APPLICATION NO.	FILING DATE	FIRST NAMED INVENTOR	ATTORNEY DOCKET NO.	CONFIRMATION NO.
10/582,198	06/09/2006	Yang Shen	0002860USU/4137 3977	
27623 7590 12/12/2007 OHLANDT, GREELEY, RUGGIERO & PERLE, LLP ONE LANDMARK SQUARE, 10TH FLOOR			EXAMINER	
			GLUCHOWSKI, KRISTINA R	
STAMFORD,	CT 06901	ART UNIT PAPER NUMBER		
			3673	
			MAIL DATE	DELIVERY MODE
			12/12/2007	PAPER

Application No.	Applicant(s)		
		10/582,198	SHEN, YANG		
	Office Action Summary	Examiner	Art Unit		
		Kristina R. Gluchowski	3673		
	The MAILING DATE of this communication appears on the cover sheet with the correspondence address Period for Reply				
WHIC - Exter after - If NO - Failu Any	ORTENED STATUTORY PERIOD FOR REPLY CHEVER IS LONGER, FROM THE MAILING DATE in the may be available under the provisions of 37 CFR 1.13 SIX (6) MONTHS from the mailing date of this communication. O period for reply is specified above, the maximum statutory period were to reply within the set or extended period for reply will, by statute, reply received by the Office later than three months after the mailing ed patent term adjustment. See 37 CFR 1.704(b).	ATE OF THIS COMMUNICATION 36(a). In no event, however, may a reply be tirr vil

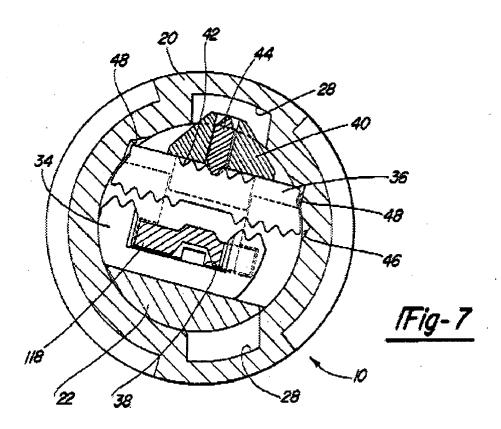
Regarding claims 7 and 22, Boag shows a key-changeable lock, including a lock 4. housing (20), a lock cylinder (10) able to rotate within the lock housing about a rotational axis, said lock cylinder including at least, a locking block (44) slidably mounted on a periphery of said locking cylinder, to be located in one of two working positions, in a first working position said locking block extends from the lock cylinder to engage the lock housing preventing rotation of the lock cylinder (figure 7) relative the lock housing and in a second working position, the locking block at least partially retracts into the lock cylinder (figure 6) to allow said relative rotation, at least one blocking piece (40) to move to selectively allow or block retraction of said locking block into said lock cylinder, at least one slide (36) to move in said lock cylinder, transverse to said rotational axis, said slide having an engaged and disengaged position with said at least one blocking piece, said at least one blocking piece moving in a fixed relationship with said at least one slide when in said engaged position, and in a variable relationship when in said disengaged position, a sliding block (34) adapted to move said at least one slide between said engaged and disengaged positions, and a locking hole (26) provided on or in the lock cylinder and into which a key (118 or 218) is inserted, characterized in that insertion of a first key into a locking hole, moves said at least one slide and in turn said at least one blocking piece, in said engaged position therewith, to allow retraction of said locking block and thus rotation of said lock cylinder, retraction of said at least one blocking piece into said lock cylinder, prevents said locking block from moving, and moves said at least one slide to said disengaged position via said sliding block, and removal of said first key and insertion of a second key moves said at least one slide and

- Regarding claim 8, the first key is removed and said second key is inserted with said cylinder in a partially rotated condition (see abstract and figures 6-7).

- Regarding claim 9, the engagement of said slide with said blocking piece is via a toothed piece (see figures 6 and 7 for illustration of teeth) on said slide engaging a toothed piece (see figures 6 and 7 for illustration of teeth) on said blocking piece, there being more teeth on one than the other to allow said variable relationship.

- Regarding claim 10, said blocking piece has a block groove (slot in top of 40 for insertion of 44) thereon running parallel to said locking block, said blocking piece, either side of said block groove, blocking retraction of said locking block, other than when said blocking piece is moved to allow said locking block to retract into said blocking groove.

- Regarding claim 11, said locking block is urged into said block groove, and is held in the block groove, by the profile of said lock housing about said lock cylinder, when said lock is unlocked (see figure 6).

- 15. Regarding claims 21 and 27, a locking groove (28) is provided on the lock housing; when the locking block is located at the first working position, the locking block is received in the locking groove; and each side face of the locking groove is provided with a guiding slant (see figure 7 for slanted edges). See the Boag device below.

FIG. 18

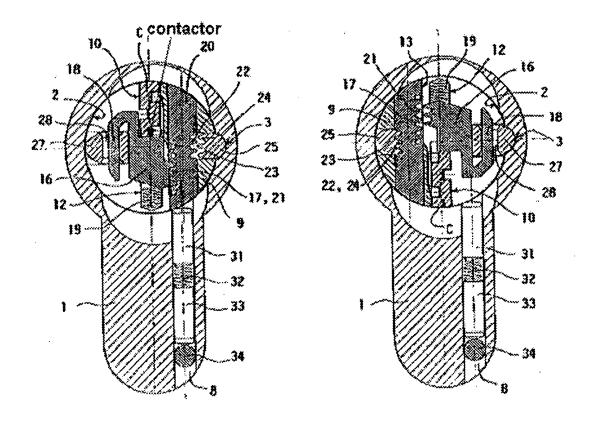
- 3. Claims 13-15 and 23-24 are rejected under 35 U.S.C. 103(a) as being unpatentable over Boag as applied to claim 7 above in view of Loreti (US 6119495). Boag shows applicant's basic inventive concept but fails to show spring bias components. Loreti shows that it is well known in the key cylinder art to include springs. Loreti shows a key-changeable lock, comprising a lock cylinder (9), a sliding block (18), toothed slides (17), and a blocking piece (20).

- 4. Regarding claims 13 and 23, Loreti shows springs (19) are provided between the sliding block and the shell.
- 5. Regarding claims 14-15 and 24, Loreti shows a compression spring (26) is provided between the toothed slide and the sliding block.

- 6. Regarding claims 13-15 and 23-24, it would have been obvious to one of ordinary skill in the art to include springs in the cylinder to assure proper engagement and movement of the components within the cylinder. It is very well known in the art to use springs. See the Loreti device below.
